This Service Information bulletin supersedes SI B33 03 14 **dated May 2014**.

Service Action/Delivery Stop: Rear Shock Absorber Guide Support

F15 (X5)

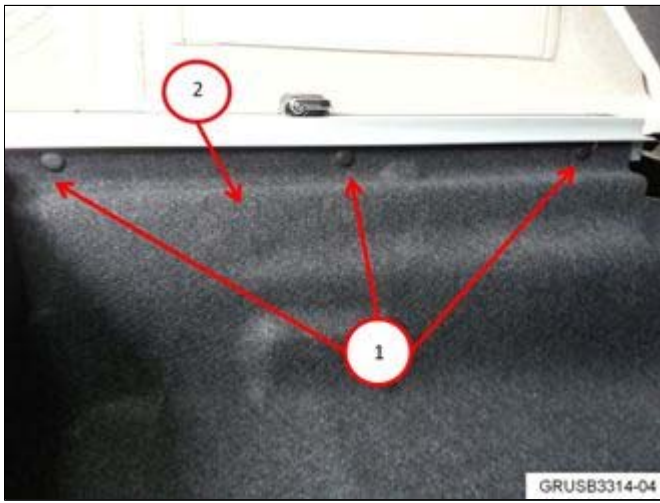
Check **both** guide supports and replace if the wrong part number parts are found.

Correct part number: 6 851 881

Incorrect part number: 6 867 864
